May 28, 2020

## **Former Kenosha Engine Plant, Proposed Stormwater Pond, NR718.12 Exemption Request**

On May 18, 2020, you requested additional information to aid in the review of the NR 718.12 exemption request to reuse on-site potentially contaminated soil at the former Kenosha Engine Plant (KEP). The information you requested is presented below in italics and the additional information is provided below each request.

ALTERNATIVE 4 - CONCEPTUAL LAYOUT  
 SOIL AND GROUNDWATER SOURCE CONTROL  
 KENOSHA ENGINE PLANT  
 KENOSHA, WISCONSIN

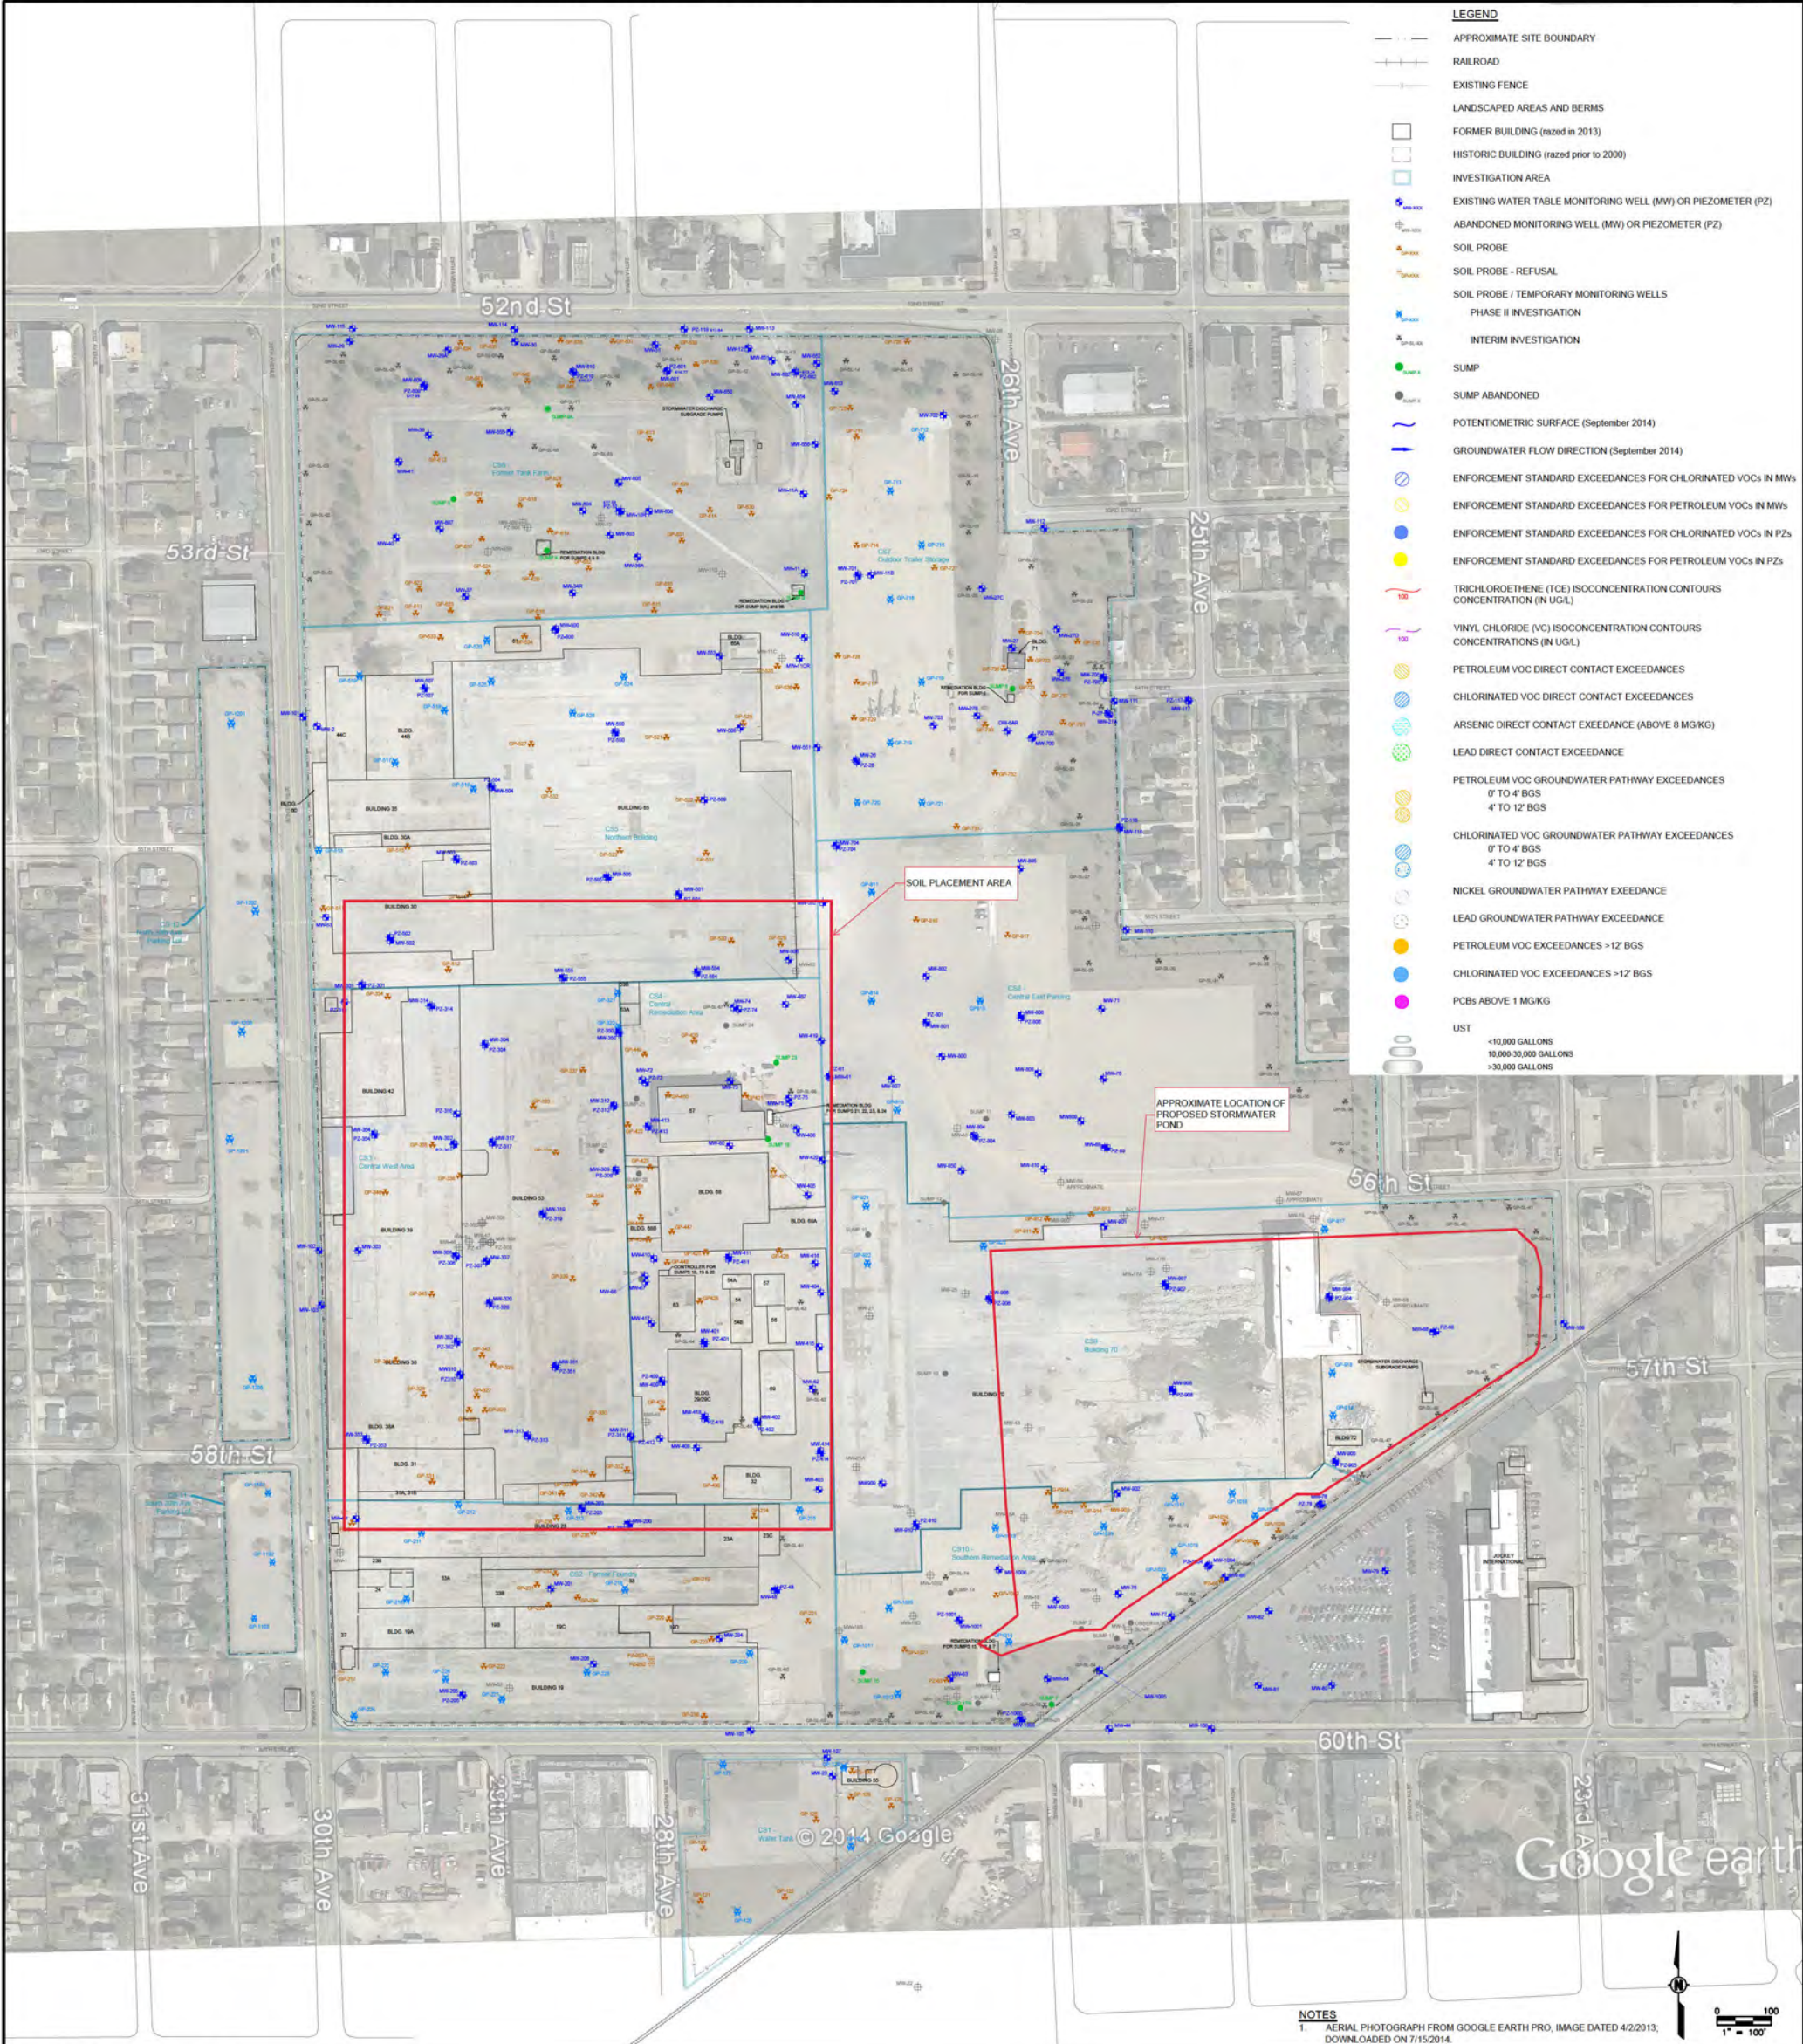
Where depicted on Figure 18, Alternative 4 – Conceptual Layout, some of the areas for capping have been re-defined by data collected later or as part of the planned excavations. The areas of groundwater treatment were further refined as identified in the Groundwater Remedial Design Report.

The storm water pond construction is not a remedial excavation. As depicted in Figure 18, Alternative #4 from the ROAR, the area of the pond did not include special capping except for one area (green shading) which had known higher PAH impacts, but not extensive enough to justify hot spot excavation using the bankruptcy escrow or grant funds allotted to the KEP for remediation which further demonstrates WDNR's previous agreement that soil impacts in the proposed stormwater pond footprint are de minimis.

- The different areas for permanent capping were identified in Figure 18, Alternative 4 Conceptual Layout, of the Remedial Action Options Report which WDNR approved. Figure 18 has been annotated to depict where the proposed pond and proposed fill areas are located, to illustrate that relatively less-impacted soil is being replaced in an area that had higher impacted soil that will receive a permanent cap.

**GROUP A AND GROUP B EXCAVATION LOCATIONS  
 KENOSHA ENGINE PLANT  
 CITY OF KENOSHA  
 KENOSHA, WISCONSIN**

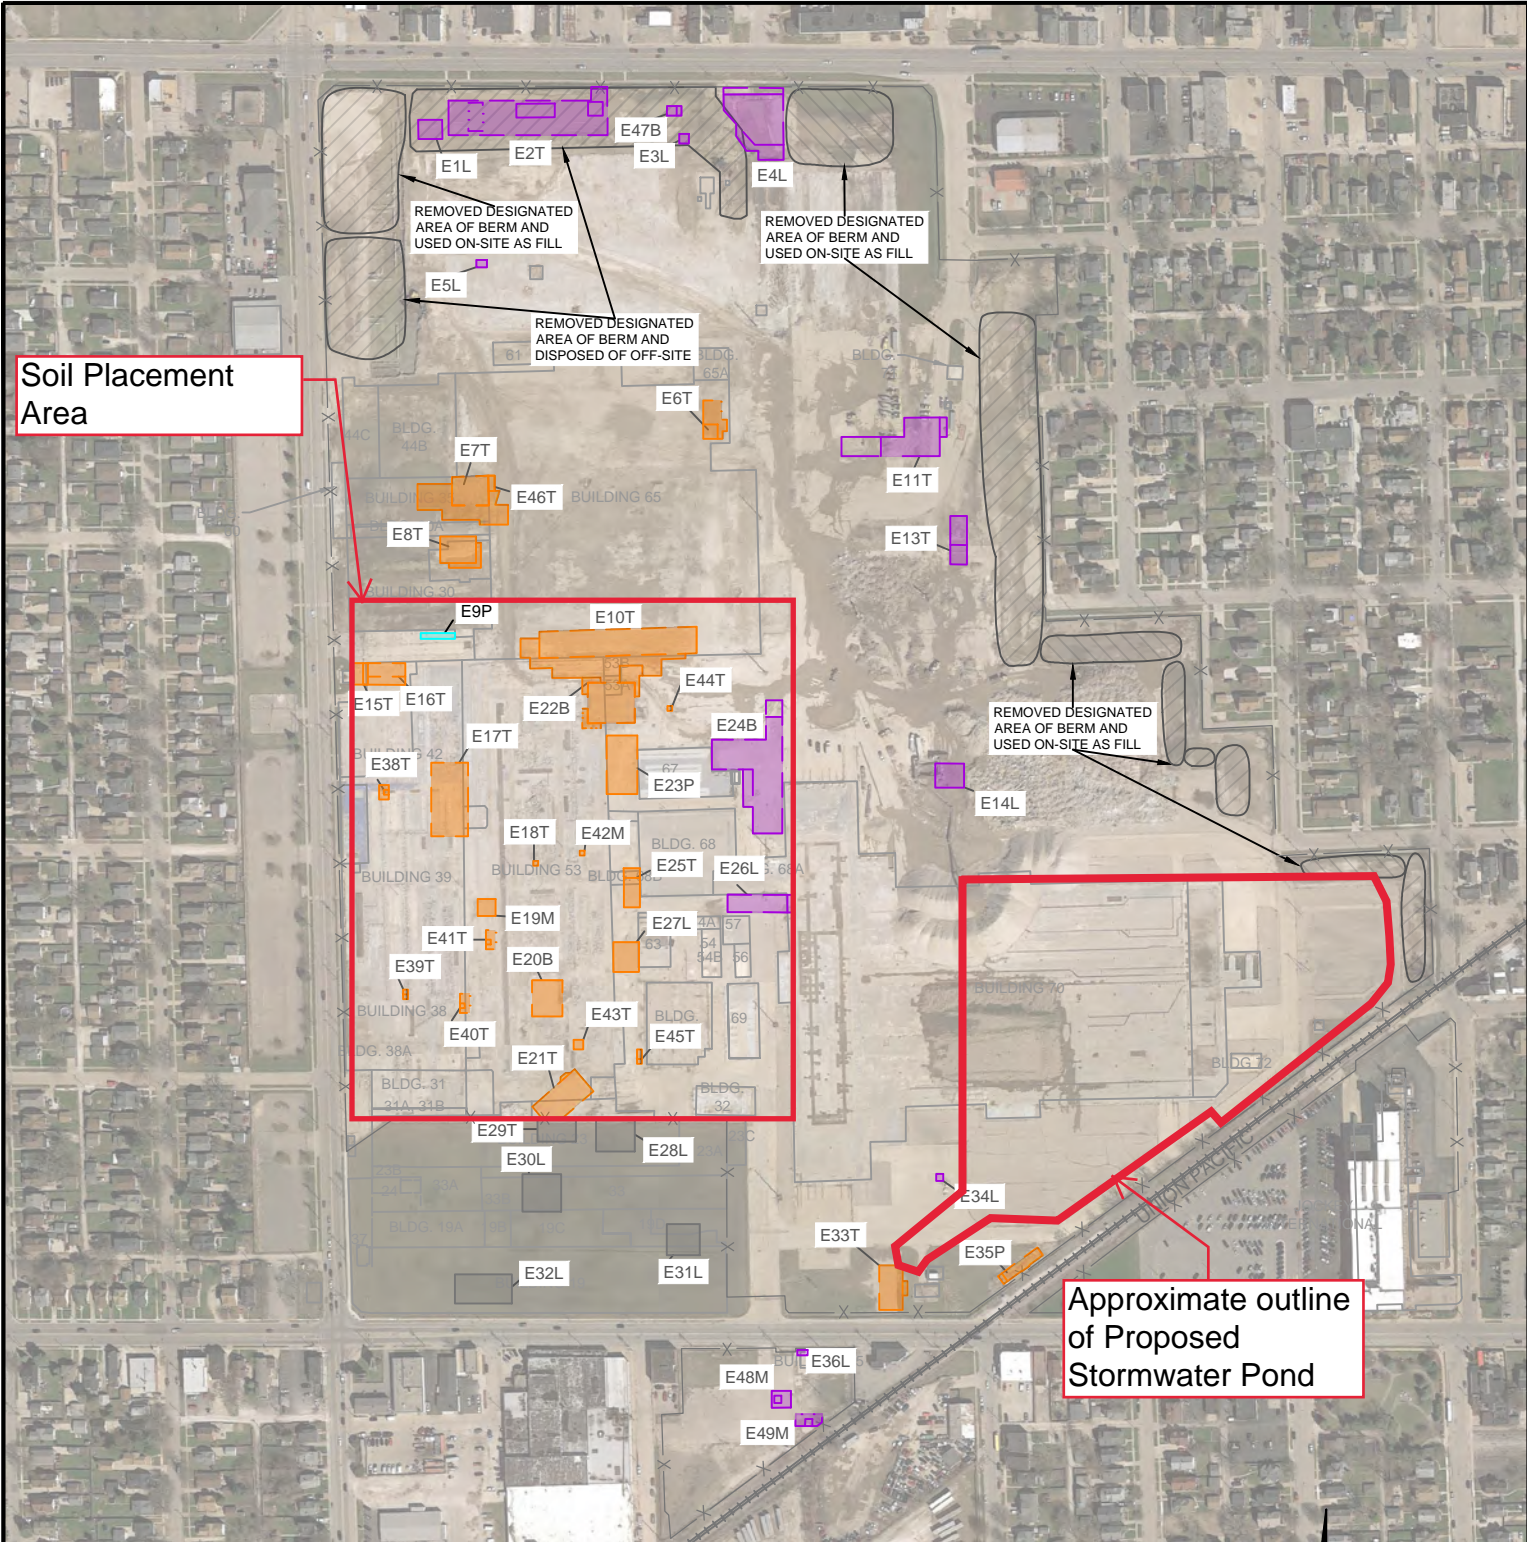
Soil contaminated with PCBs will not be moved or relocated. As shown on Figure 3 “Group A and Group B Excavation Locations” from the first phase of soil remediation, PCBs depicted in the ROAR figure were removed by excavation (E35P-as depicted on Figure 3 Group A and Group B Excavation Locations from the 2016 Soil Remediation Report) and are no longer an issue for management at the KEP.

One of the main contaminants at the KEP is chlorinated VOCs. As depicted on Figure 3, Group A and Group B Excavation Locations from the Remediation Documentation report, multiple excavations were conducted in the area proposed for soil placement to removed soil with TCE concentrations above 1,000 ug/kg. This value was chosen with WDNR approval of the approach as is confirmed by the WDNR approval of the Soil Remedial Design (2016) document based on empirical evidence from TCE concentrations in the groundwater. The residual concentrations of TCE in the excavations were included in the Soil Remediation Documentation report. As such, the soil being moved has TCE concentrations that are much less than the residual concentration in the area of soil placement. Additionally, area proposed for soil placement will receive a permanent cap with redevelopment.

- Soil from the berms in the vicinity of the pond are gone and the land surface on the eastern side of the proposed pond is at street level.
- A copy of Figure 3, Group A and Group B Excavation Locations has been annotated with the approximate pond boundary and the proposed soil placement area. The pond is not located over any remedial excavations. However, the inlet to the pond may touch the northern portion of the Group B excavation identified as E33 T. This excavation was backfilled with clay approved as clean by WDNR from an off-site source. Any backfill excavated will be placed in the proposed location and treated like other soils. The residual concentrations of VOCs in the northern part of the pond were low and exceeded only the groundwater pathway RCLs. The construction of the inlet to the pond is not expected to cause residual impacts to leach into the groundwater.
